RESOLUTION 21-112

A RESOLUTION REQUESTING ADHERANCE TO THE CONDITIONS OF APPROVAL FOR NEIGHBORHOOD CONCEPT PLAN 489-2018.

RE: Resolution requesting adherence to Neighborhood Concept Plan condition of approval

14. **NCP 489-2018:** Submitted by ESP Associates for Southern Springs Phases 7 & 8. The property is zoned B-4, Central Business district and contains approximately 90 acres. The applicant requests a neighborhood concept plan approval for 201 single family residential lots.

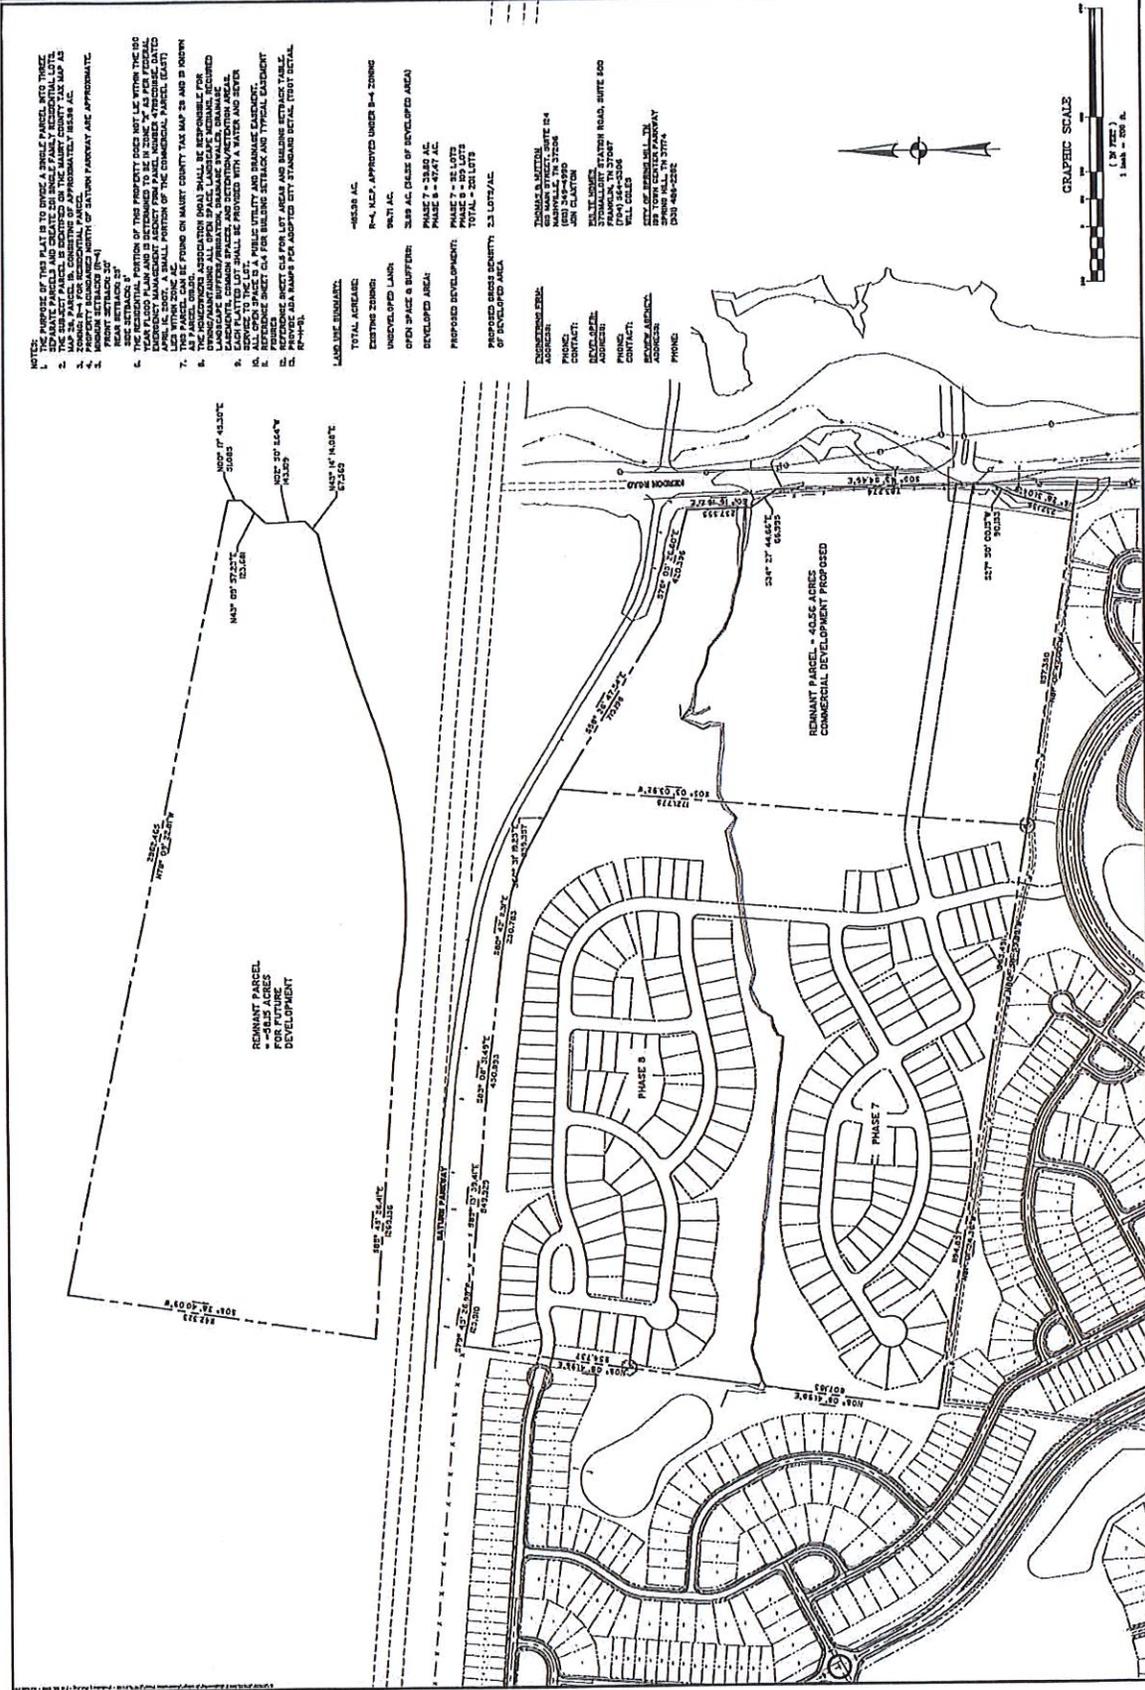
1. Approval of the neighborhood concept plan shall be valid for a period of three (3) years during which time a preliminary plat application must be submitted for Planning Commission review and approval.
2. Modifications to the approved neighborhood concept plan may require Planning Commission approval prior to submittal of a preliminary plat application.
3. Walking trails to be a minimum of 8 feet wide and a hard stable walking surface.
4. Modify the access note on Sheet 1 and elsewhere to read: The emergency access roadway from Hardin Place to Kedron Road shall be provided by the developer if the adjacent commercial site to the east does not develop and provide such access prior to the development of Phase 7. The emergency access is to be constructed to city street standards; including construction and dedication.

Alderman Fitterer made a motion to approve **NCP 489-2018** with staff provided conditions. Motion seconded by Commissioner Graham. Motion passed 7/0.
